Panel Reference	PPSHCC-47
DA Number	DA 20/558
LGA	Maitland
Proposed Development	Residential Flat Building – Affordable housing (3 stories, 18 Units), demolition of two existing dwellings and ancillary structures, lot consolidation and associated site works
Street Address	Lots 4-6, DP35465, 15-19 Fieldsend Street, East Maitland
Applicant	NSW Land and Housing Corporation
Owner	Department of Housing
Date of DA lodgement	18 June 2020
Total Number of Submissions Number of Unique Objections	Original notification: 4, plus one (1) petition with 20 Signatures Re-notification: 2
Recommendation	1. Granting of approval, subject to the recommended conditions of consent set out in Appendix A; and 2. Section 7.11 contributions for this development be waived
Regional Development Criteria (Schedule 7 of the SEPP (State and Regional Development) 2011	Crown development above \$5 million CIV Private infrastructure and community facilities (Affordable Housing) above \$5 million CIV

EXECUTIVE SUMMARY

The purpose of this report is to provide a detailed assessment of Development Application (DA) 20/558 for a Three (3) Storey Affordable Housing Residential Flat Building - 18 Units (7 x 2 bed, 11 x 1 bed)

Picture of overshadowing
on Barton Street
at 10AM on Sunday 12th July 2020

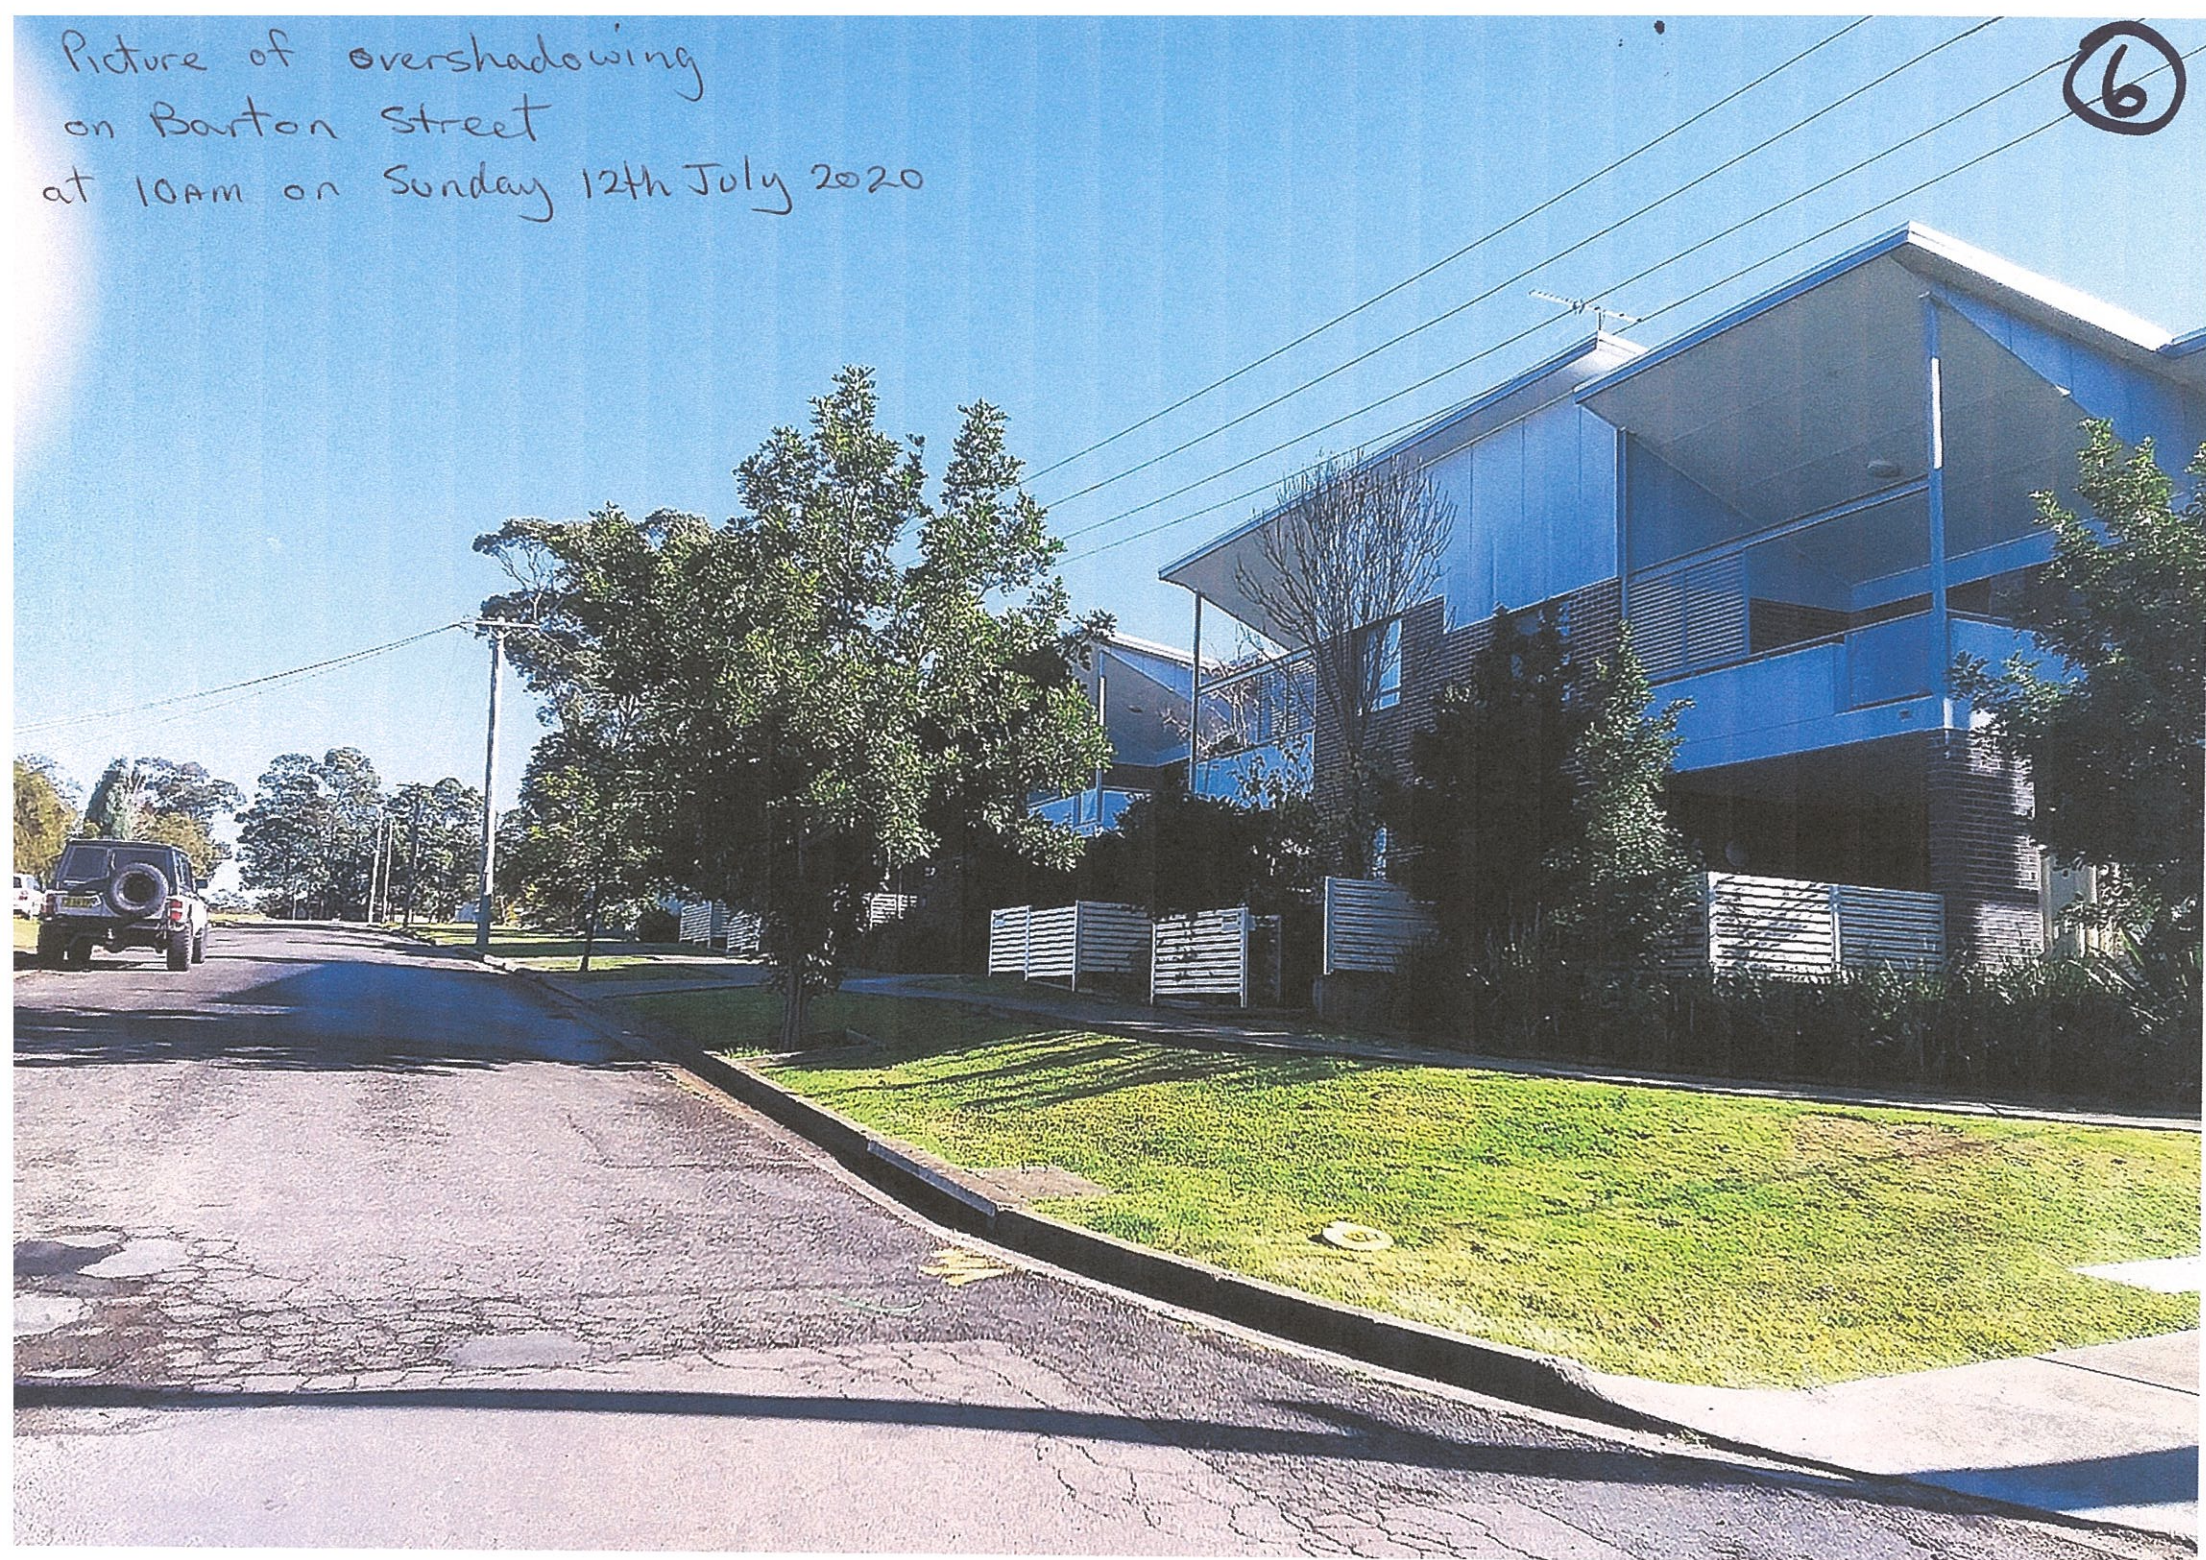
Photos 1, 2, 3, 4 show the shadow from the tree. The photo provided in the DA of the front of my property has been taken in late afternoon as can be seen by the variation and position of the shadow.
